Open Issues

Problems on parts and components (INFN-Pisa)

Tower Zero Assembly Activities

Cable Holding Plate assembling before Tower Turn Over

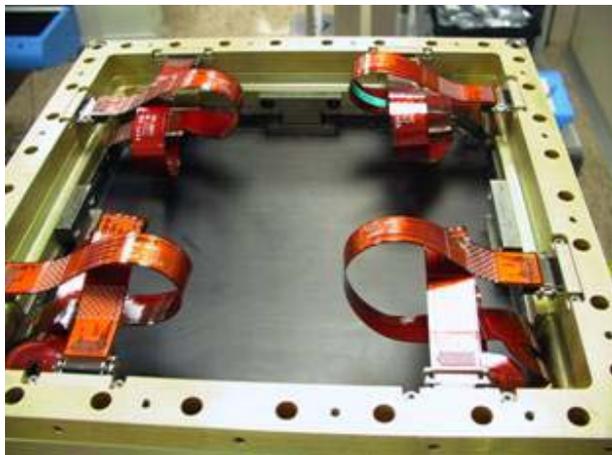
1. Cables on Cable Holding Plate are twisted (figures 1 and 2). Concerns about this configuration during vibe tests.
2. Modification of Cactus Arm bending tool required.

Top Cables Bending

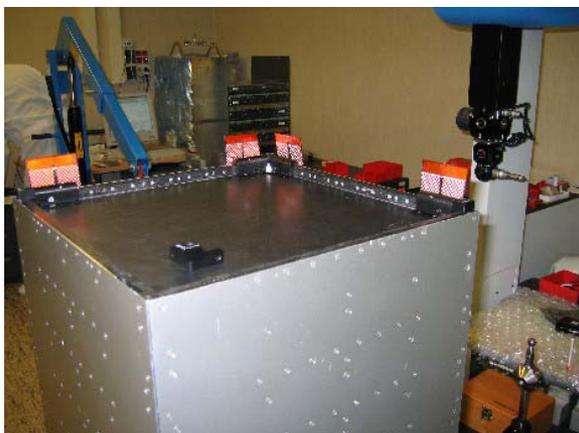
5. Improve assembling of Top Bracket and Cables Top Bending (figures 3 and 4):
 - Tape needs to be placed over the gaps between the closeouts on the top tray and the sidewalls to prevent object falling.

- Care needs to be taken to push the cables all the way against the clip when placing the mid screw.
 - After pushing the cable down there was no more interference and the third screw could be installed (figure 4).

- The holes -X-Y corner bracket didn't match up with the holes in the top tray.
 - Use adhesive tape to attempt to hold the cables to the brackets doesn't appear to be necessary or helpful.
